**LEGAL ADVERTISEMENT
HISTORIC PRESERVATION BOARD
CITY OF PORTLAND
Public comments are taken at all meetings.**

CITY OF PORTLAND, MAINE
HISTORIC PRESERVATION BOARD

**WORKSHOP
100 COMMERCIAL STREET (THOMAS BLOCK)**

**PUBLIC HEARING
392 SPRING STREET**

Att. 1
ORIGINAL
PROPOSAL

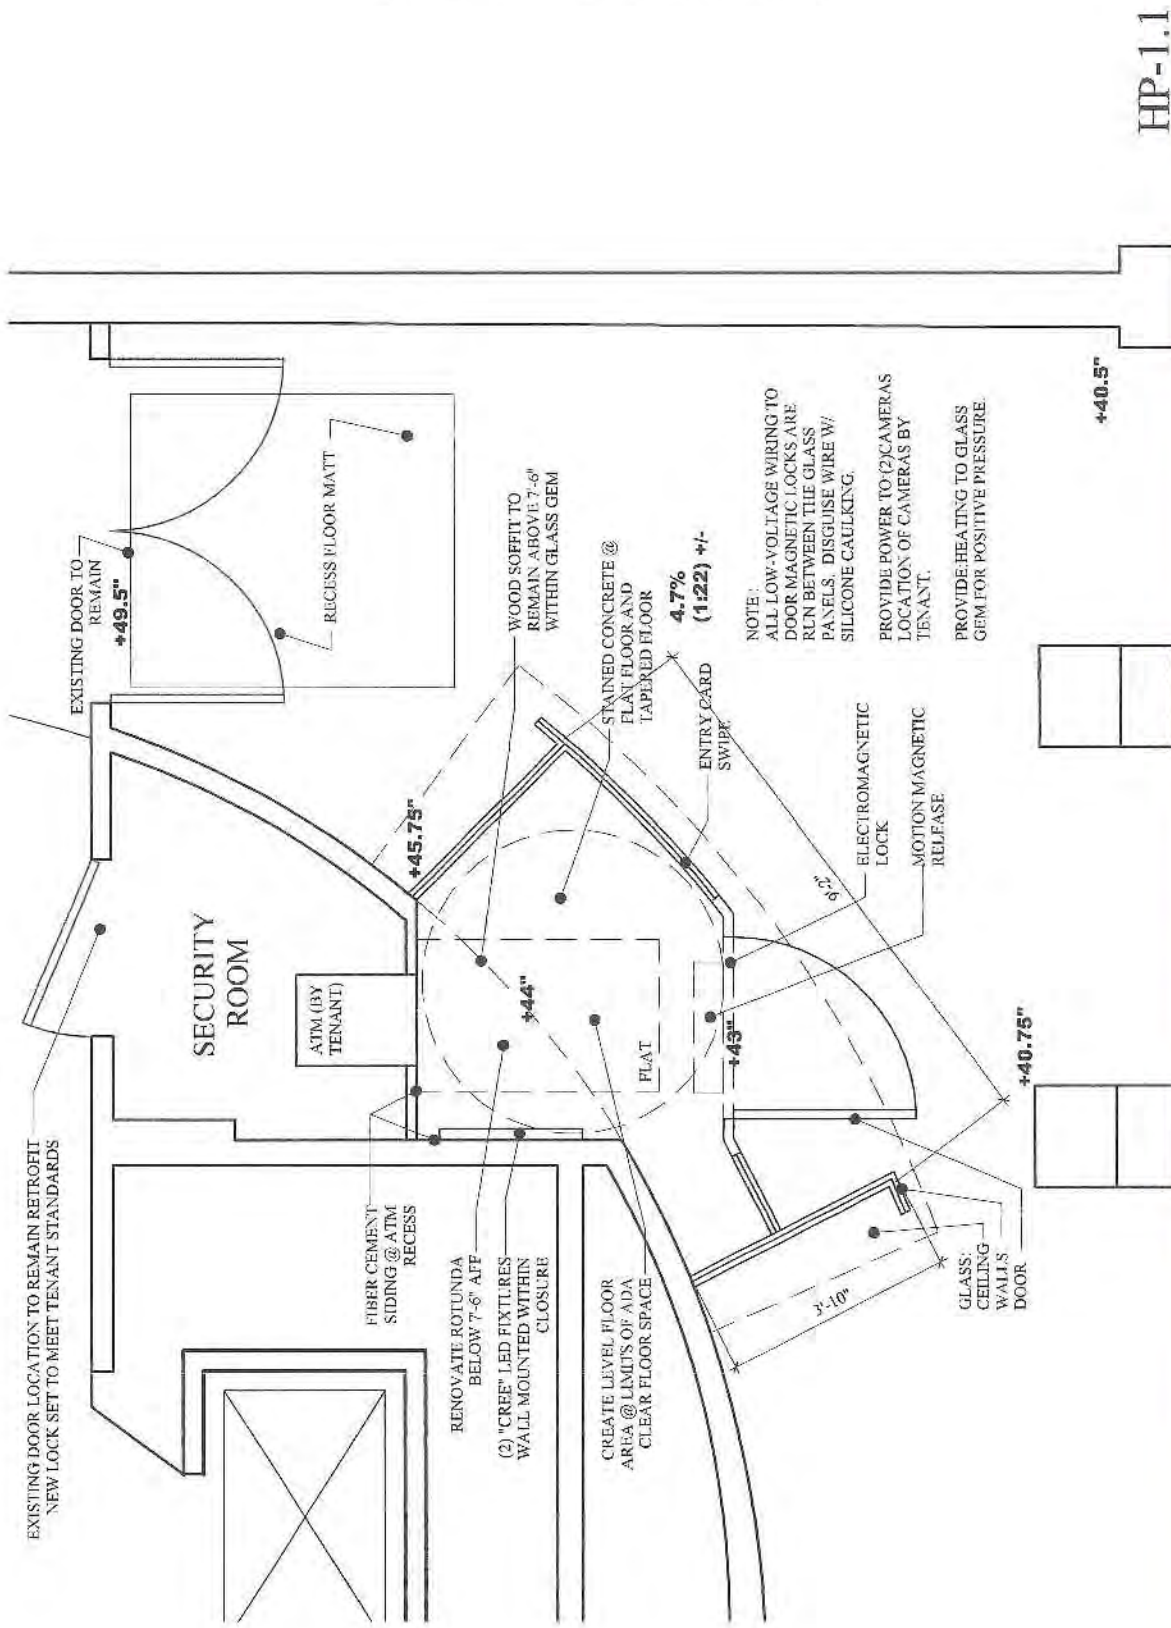
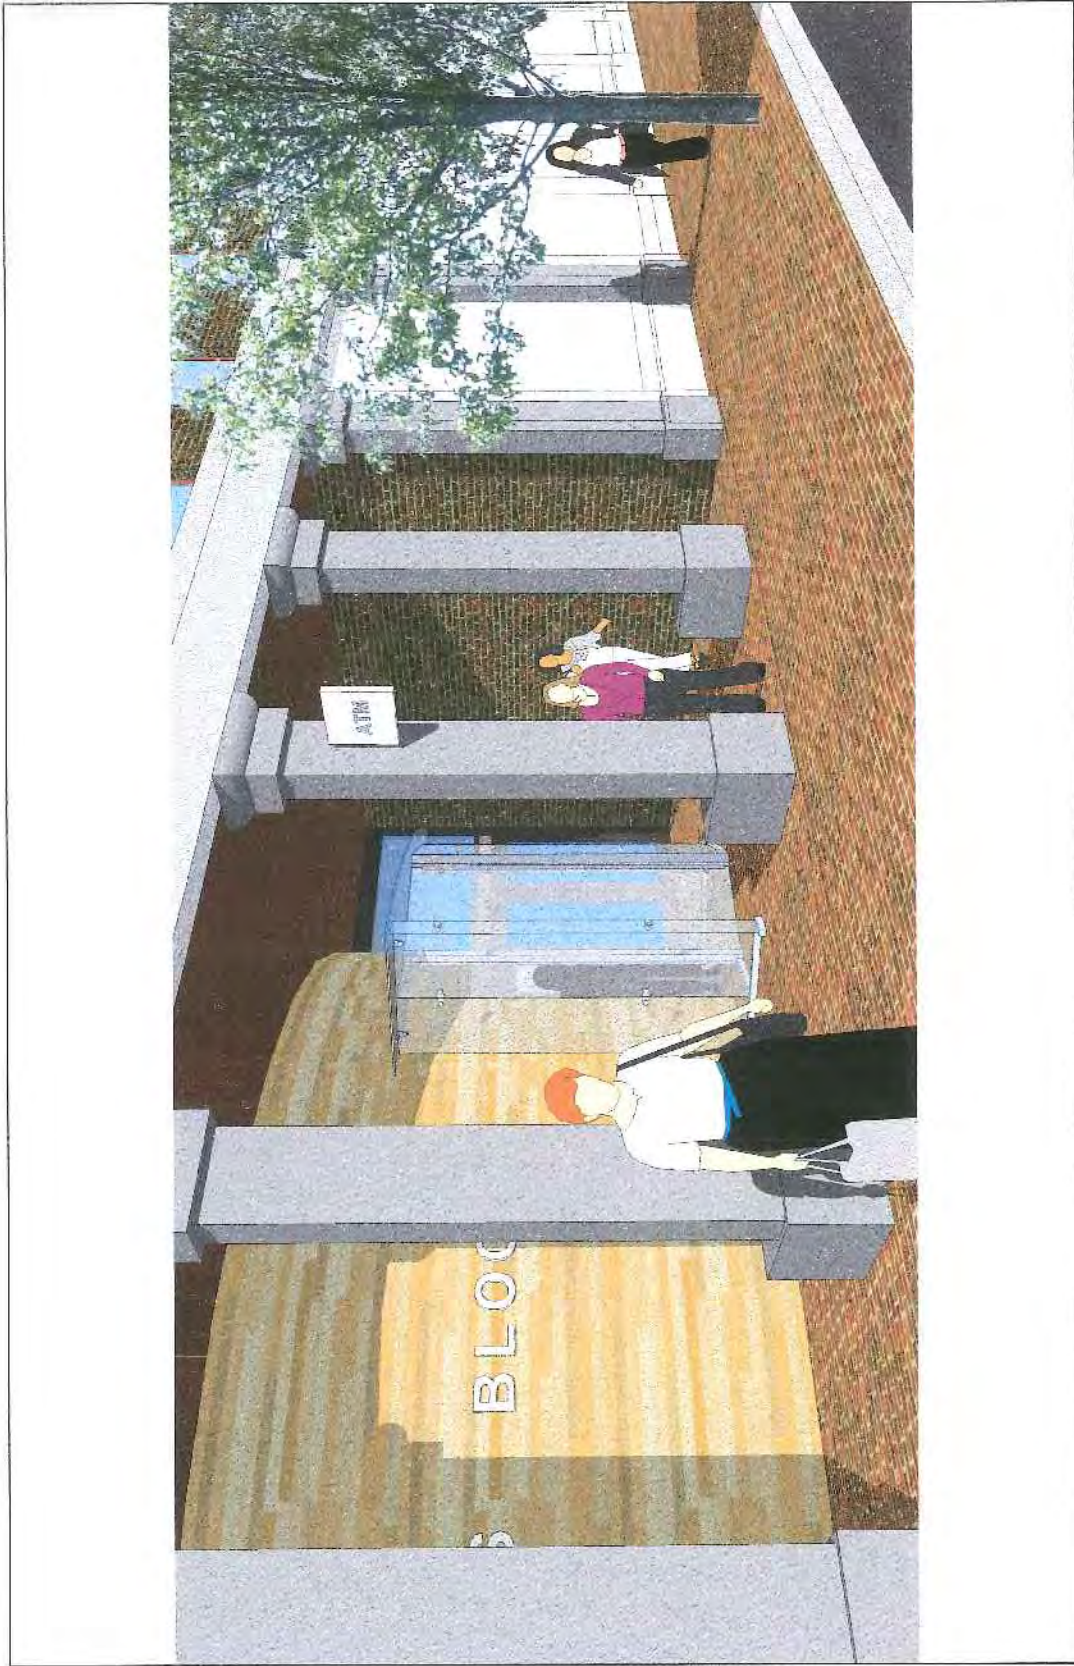
In February, architect Mark Mueller presented plans for the addition of an ATM enclosure at the main entrance to the Thomas Block. (See ATTACHMENT 1 for original proposal.) Board members will recall that the plans called for cutting into the convex exterior wall at the

building entrance (which features a natural wood finish) and installing an ATM within a new wall plane. A frameless glass-walled enclosure was proposed to project beyond the face of the existing curved wall to provide an airlock and protection for the ATM.

Board members did not support the proposal as presented, finding that the proposed ATM addition was incompatible with the overall architectural expression of the existing building entrance. They noted that the existing entry treatment, while not original to the building and the product of a 1975 renovation, was noteworthy for its strong geometry, simplicity of architectural expression and natural wood veneer. Board members argued that to cut into the curved wall to accommodate an ATM installation and introduce a frameless glass building addition in front of the natural wood exterior wall would muddle the existing composition and material palette. While acknowledging the architect's efforts to make the enclosure addition as visually transparent as possible, the proposed enclosure would inevitably read as an after-the-fact addition that is not integrated into the overall architectural expression of the building entrance.

ATT. 2A
 PRELIMINARY
 PROPOSAL PRESENTED
 OCTOBER 7

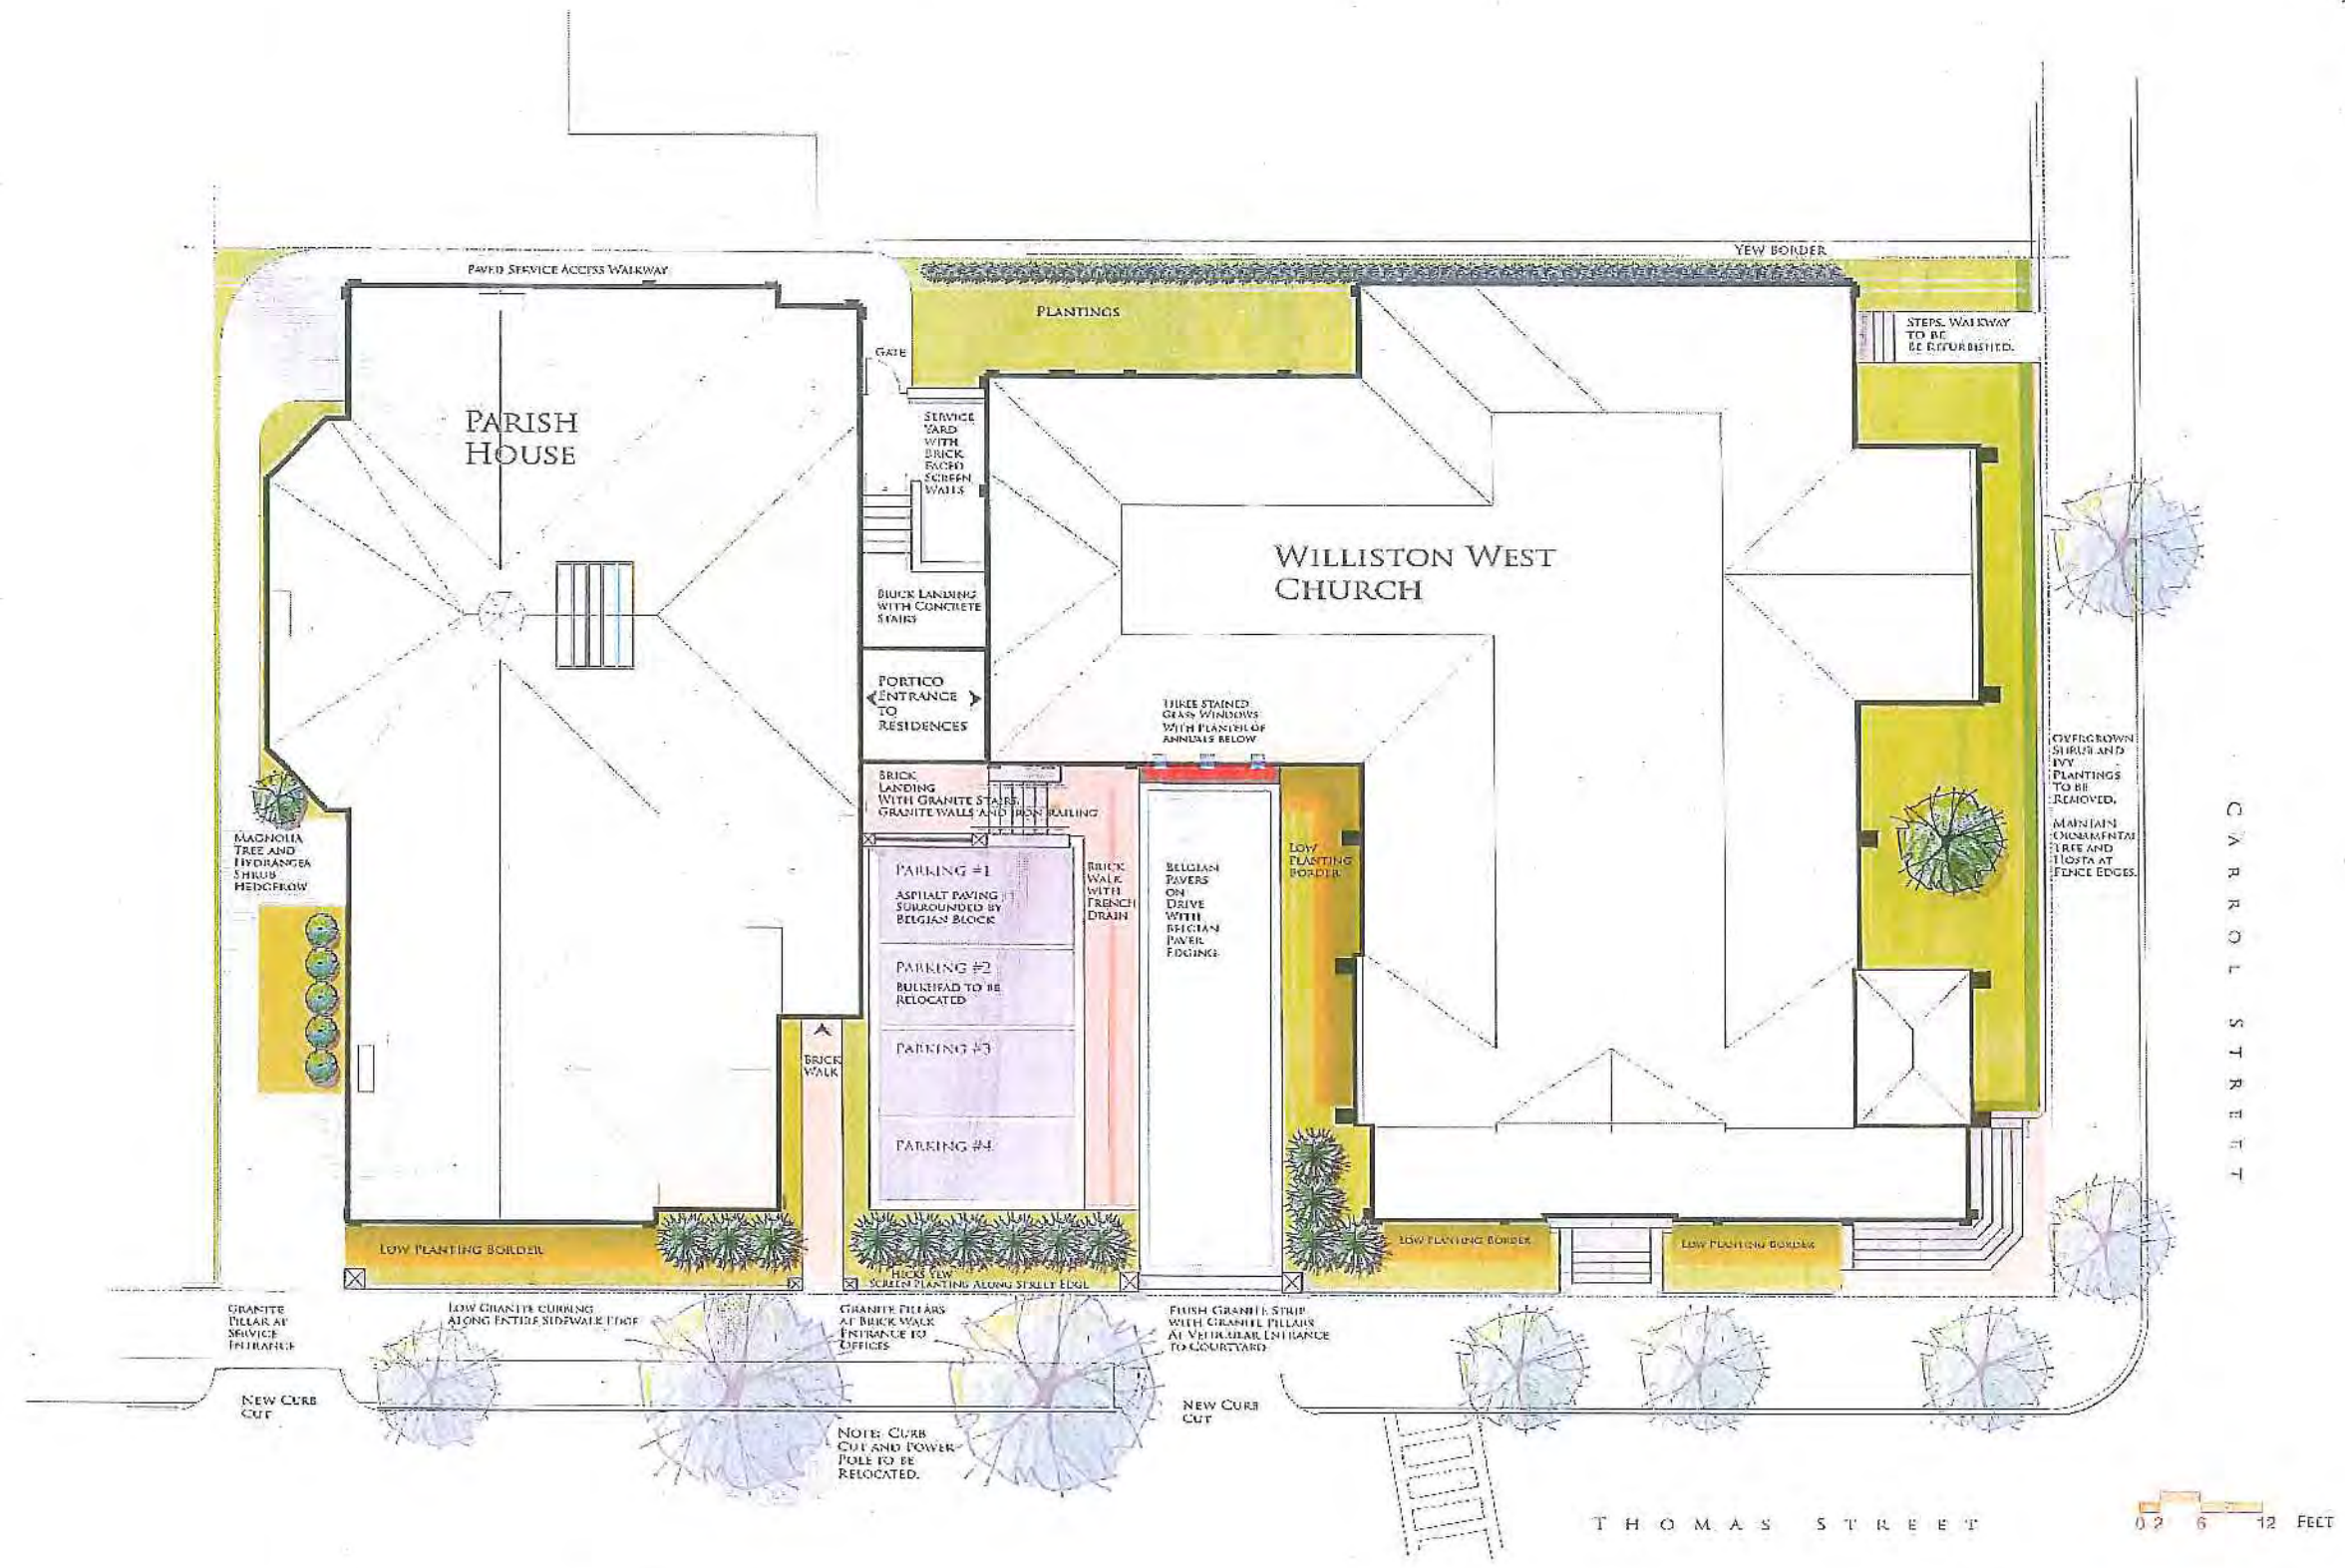
On October 7th, the Historic Preservation Board held a workshop to review preliminary plans for the proposed site alterations and building addition. (See ATTACHMENT 2 for copy of October 7 plans.) Based on Board comments, it appeared that most members were generally

comfortable with the concept of introducing parking within the courtyard area provided it could be done in such a way that was compatible with the historic character of the building complex and did not visually distract from the buildings themselves. With respect to the specific site plan presented for consideration, the Board questioned a number of aspects of the proposal, including the position of the drive and parking area, the proposal for a walkway positioned directly behind the area for parked cars, the number of paving materials shown within the small courtyard area, etc. Board members also commented that the plan appeared to be overly complicated in terms of the number of individual features. They expressed a preference for bringing all residents into the parish hall through the existing entrance portico, thus eliminating the need for separate entries, separate walkways, etc. If this was not possible, they suggested that consideration be given to introducing a "spur" off the existing walkway that would lead to the new entrance within the connector. Given the concerns, the Board encouraged exploration of modified or alternative design solutions that reduced the number of added site elements, simplified the material palette, reduced the width of the driveway and effectively mitigated the impact of parking.

2. Straight stairs into the new Portico

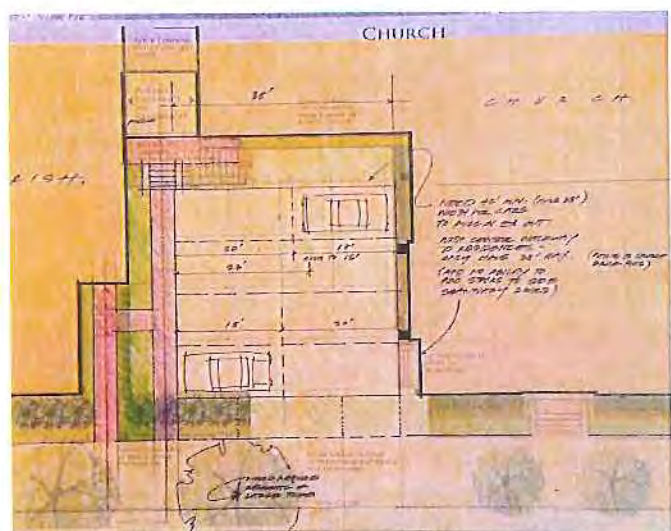
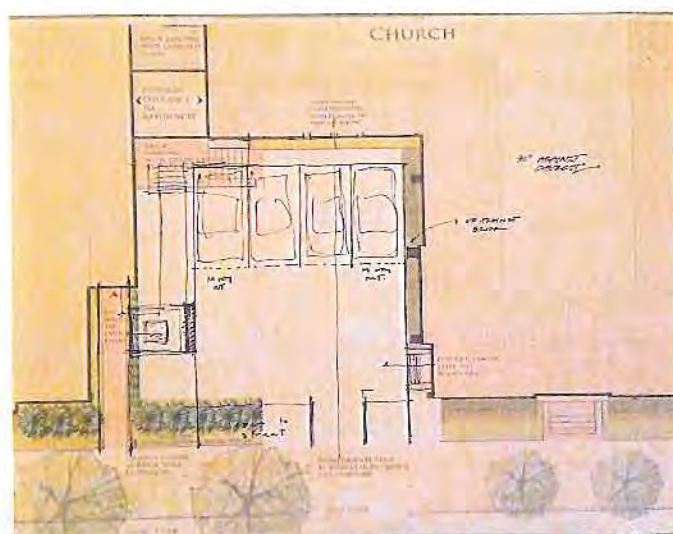
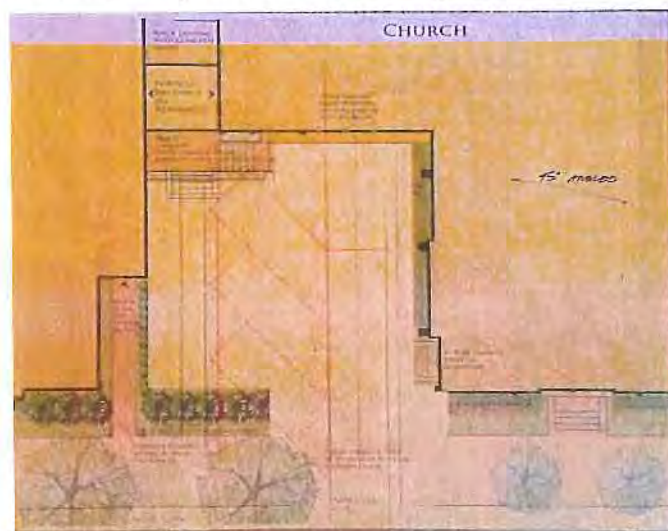
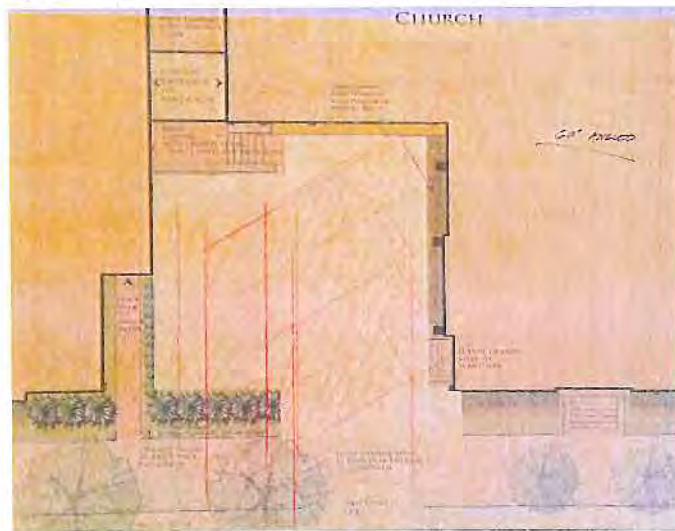
The stairs leading to the Residential entrance on the 10/21 plan climb up, north to south, approaching the portico at a 90-degree angle to the door.

The HPC questioned if straightening the stairs to the portico might allow for a more direct walkway connection between the Residential and Office entrances, thereby requiring only one access point from Thomas Street into the site.

The site sketches below illustrate the result of turning the stairs to allow a straight entrance from the parking area to the Residential portico. As the stairs would center on the portico opening, the remainder of site that is left for parking is too small to accommodate the turning radius required for car movement in and out of the site. There is a total of 38' from stair edge to Church building wall. A 42' width is required for 90 degree stall parking. Head-in parking would fit (36' width required for (4) nine foot car stalls) but in order to access these spaces, the entire site would be paved from Thomas Street in to the spaces. Two layouts were attempted using 45 and 60 degree stalls – both accommodating only 3 cars each and both bringing cars into to the sidewalk. Trying all four of these layouts using compact car dimensions still did not allow adequate turning room and created a solid expanse of paving from the stairs to the Church wall.

Conclusion: Moving the stairs to enter the portico straight from the parking area takes too much space out of the courtyard to design an efficient, workable or aesthetically pleasing parking layout.
